M2024023, Brown Quarry Application, Initial Adequacy Review

Re: Brown Quarry Application (M-2024-023)
Initial Adequacy Review

The Division has completed an initial review of the materials submitted with the Brown Quarry 110c application. Comments are organized by rule citation. Please review the following comments and address the numbered items in bold.

Figure 1: Screenshot of the General Location Map, georeferenced by section lines (red), with inspection features (green) and digitized permit boundary (purple)

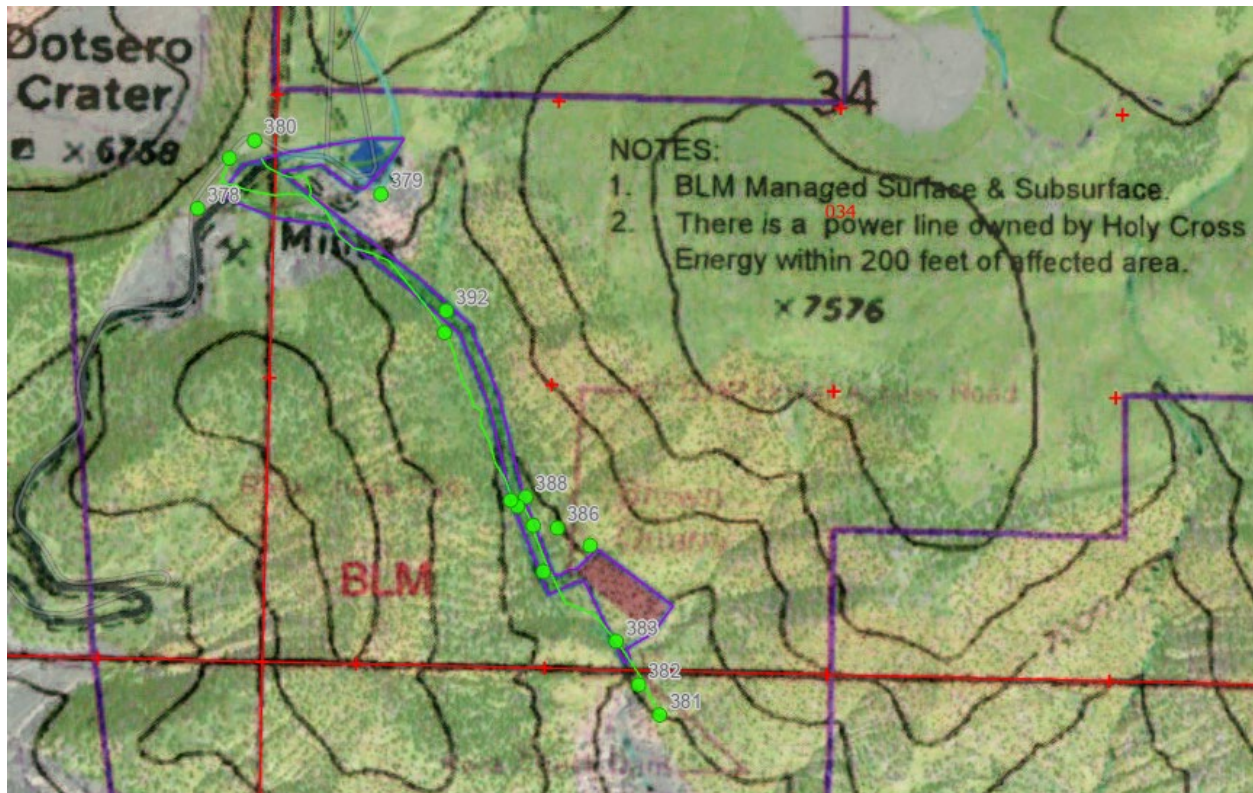
1. Exhibit A gives three distinct legal descriptions: The Yard (0.43 acres), Brown Quarry (1.52 acres), and Peachblow Quarry (1.66 acres). Peachblow Quarry is not referred to anywhere else in the application packet.

The General Location Map given with Exhibit A (which is the only map showing the permit boundary) was georeferenced using the projected section lines. The permit boundary was digitized and measured at approximately 9.24 acres. Labels on the map are indistinct, but "Brown Quarry" can be made out. "The Yard" and "Peachblow Quarry" labels are not visible. (See Figure 1)

- a. **Please revise Exhibit A so that the text and the map agree; presumably the reference to Peachblow Quarry should be removed. (Keep in mind that for a 110c permit the permit area and the affected area are equivalent.)**
- b. **Please update Exhibit A to specify coordinates of latitude and longitude of the entrance to the site in degrees, minutes and seconds, or in decimal degrees to an accuracy of at least five (5) decimal places.**
- c. **Please ensure that all areas referred to in the text are labelled on the map.**
